INTERCHANGEABILITY OF INPUT SHAFTS

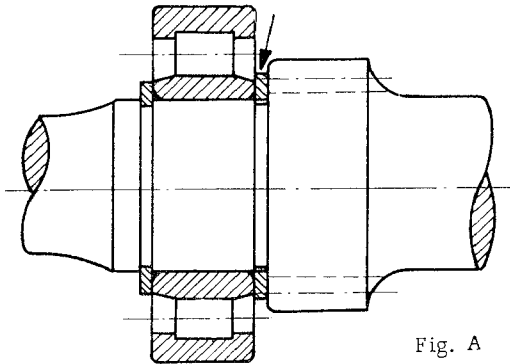
Fig. A illustrates the standard location of an intermediate ring between gear 1 for the 1st speed on the input shaft 741.302.101.10 and the roller bearing, from transmission No. 51017.

The intermediate ring has spare part No. 741.302.296.00.

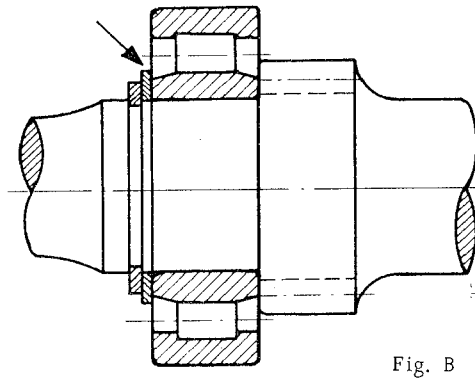
Fig. B illustrates the location of the intermediate ring when installed with input shaft 741.302.101.10 in a transmission housing 644.20.010 or 716.301.010 or 741.301.010.00.

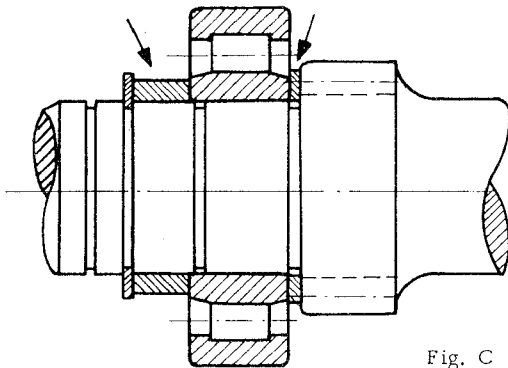
Fig. C illustrates the location of the intermediate ring and distance ring, when installed with input shaft 519.20.249 in a transmission housing 741.301.010.10.

The distance ring has spare part No. 644.20.209.
